Memorandum

To Anna Linnios
Date 04 April 2025
Copies Adam Marshall, Lauren Boysen
Reference number 298160-00
From Sina Hassanli
File reference
Subject o State Design Review Panel

Herein, please find a concise summary addressing the comments provided by the State Design Review Panel (SDRP) in their design review 5 relating to the Environmental Wind Assessment Report for Crows Nest OSD – Site B (Revision 5, dated 11 March 2025).

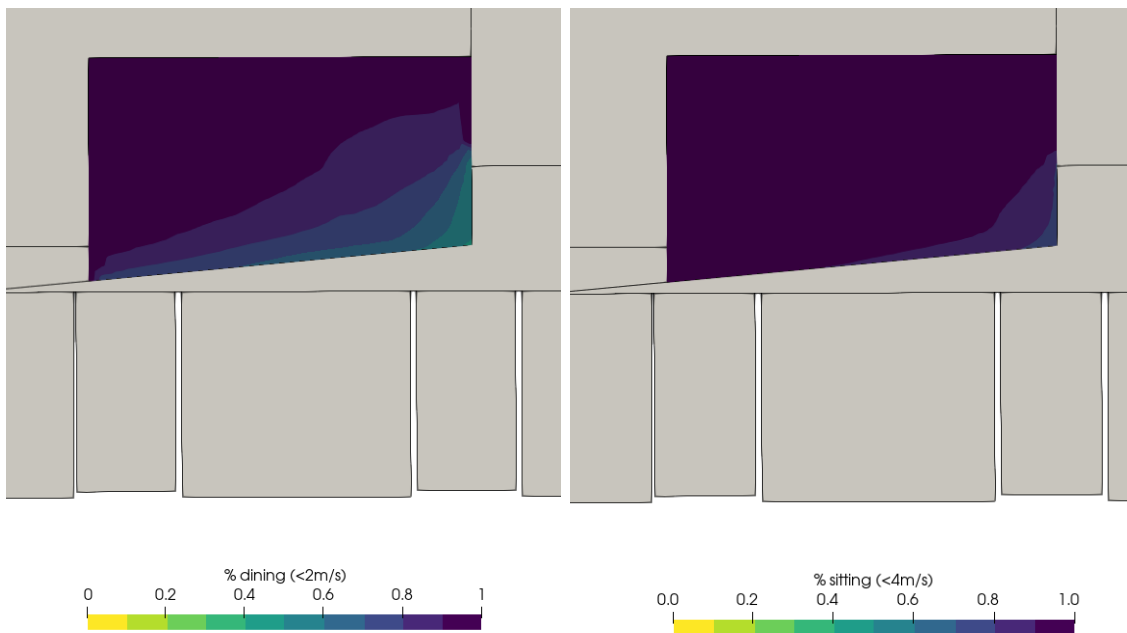
Item 3

The wind report presents the wind conditions for the upper-level balconies in Figure 21, and for the mid- and lower-level balconies in Figures 39 and 40 (Appendix), respectively. Upper-level balconies are generally subject to higher wind speeds due to reduced shielding from surrounding structures and elevated exposure. As a general guideline, balconies should be designed to achieve *sitting* or *standing* (depending on its location) or better wind conditions across the majority of their floor area, with no areas classified as uncomfortable.

The analysis indicates that, aside from the north-east and south-west corner balconies, most balconies are suitable for *dining*-type activities (i.e., wind speeds below 2 m/s for 95% of the time or more). Even for the corner balconies, the inner half (at least 50% of the area) remains suitable for *dining*, with 80% of the area classified as suitable for *sitting*. As expected, higher wind speeds are observed at the more exposed corners; however, over 80% of the balcony area still experiences wind speeds below 2 m/s for more than 80% of the time, and more than 95% of the balcony area experiences wind speeds below 4 m/s (corresponding to *sitting*) for 90% of the time or more. Refer to the figure below, which presents the percentage of time the wind remains below 2 m/s and 4 m/s on the south-west corner balcony—the most affected by wind (0-1 equivalent to 0-100%).

As these are privately accessed balconies, the conditions are considered acceptable, given that usage is likely to be minimal during very windy conditions. If further improvement is sought for corner balconies, one potential mitigation is to install a blade wall along one side.
